ADDENDUM #1 – OCTOBER 7, 2025

**RE: EASTSIDE FIRE STATION
Seismic Grant Upgrade REBID
Project #22.22.2**

**FROM: HGE ARCHITECTS, Inc.
333 South 4th Street
Coos Bay, Oregon 97420
541-269-1166**

2 NEW 1-LINE DIAGRAM
E1.0 120/240 VOLT, 1-PHASE

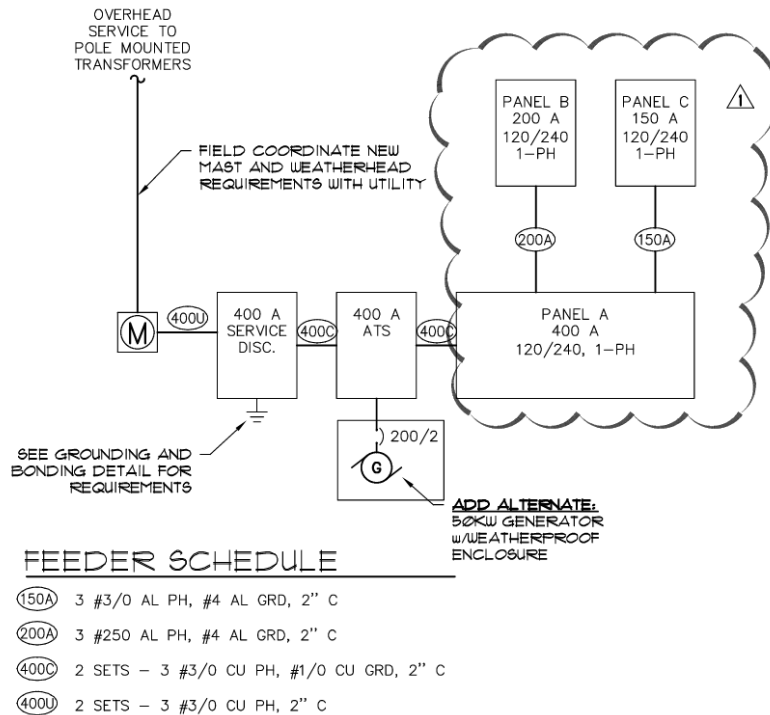
- Sheet AD2.2 2nd Floor and Roof Demo Plans:** ADD note at Restroom, "Existing flooring and plumbing fixtures to remain. Remove existing ceiling." Refer to Room Finish Schedule on Sheet A7.1.
- Sheet E1.0 Electrical Plan Symbols & Schedules:** REPLACE New 1-Line Diagram with revised 1-Line diagram attached below to add Panel B:

- Sheet E2.0 Electrical Plan Lighting & Sheet E3.0 Electrical Plan Power & Data:** Next to Panel A, ADD Panel B with note "Panel 'B', 120/240 Volt, 1-Ph, 200 Amp."

SKETCH NO:
SSK-01

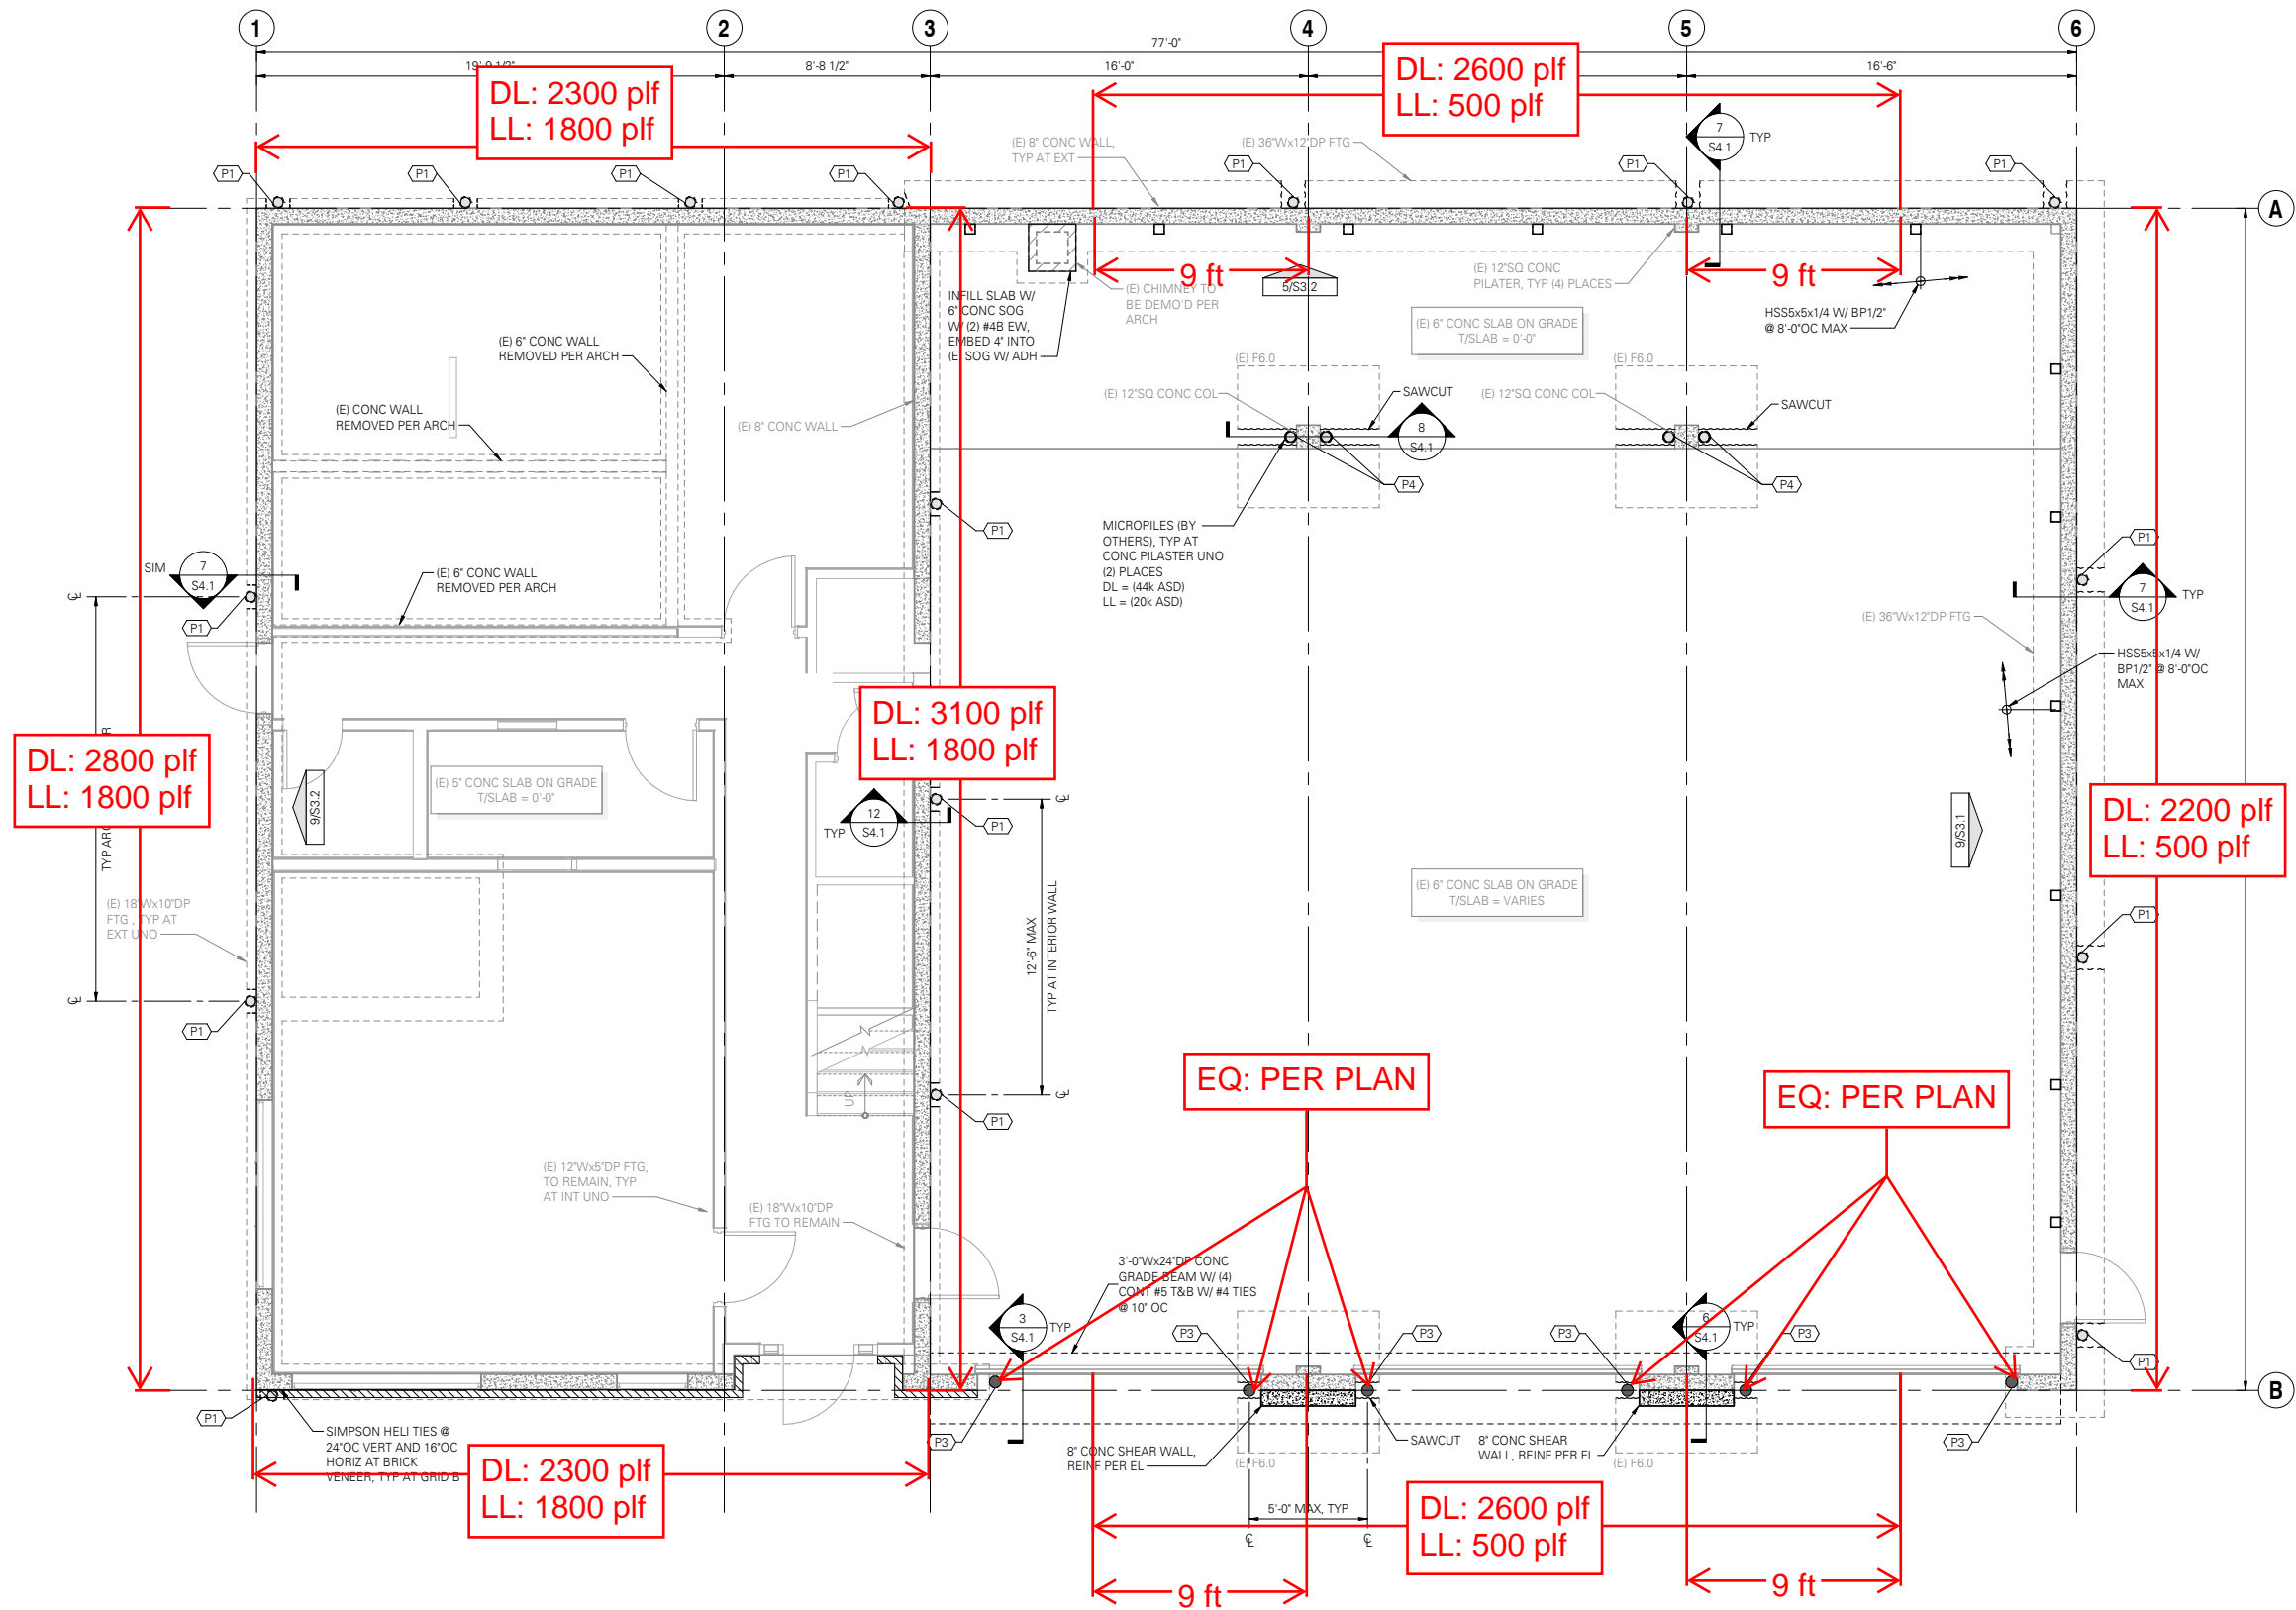
1. **Section 01-2300 Alternates:** REVISE Paragraph 1.03 E, Alternate No. 5:
 - a. Base Bid Item: ADD "Provide flooring at second floor landing of Stair #21."
 - b. Alternate Item: REPLACE with the following: "In addition to Base Bid work, provide flooring in Day Room #22 and (3) Door Rooms #25, 26, 27, and provide all casework & countertops, kitchen sink, faucet, and garbage disposal. Range, hood, and refrigerator by Owner. Refer to Drawings and Specifications."
2. **Section 31-6200 Steel Pipe Piles:** ADD Section in its entirety, including sketch from DCI Engineers, SSK-01 Unfactored Loading on Foundation Plan, for dead and live line loads along walls for micropiles/helical piles. This loading plan is for the contractor's use in confirming pile quantity and layout, per request from potential bidder.
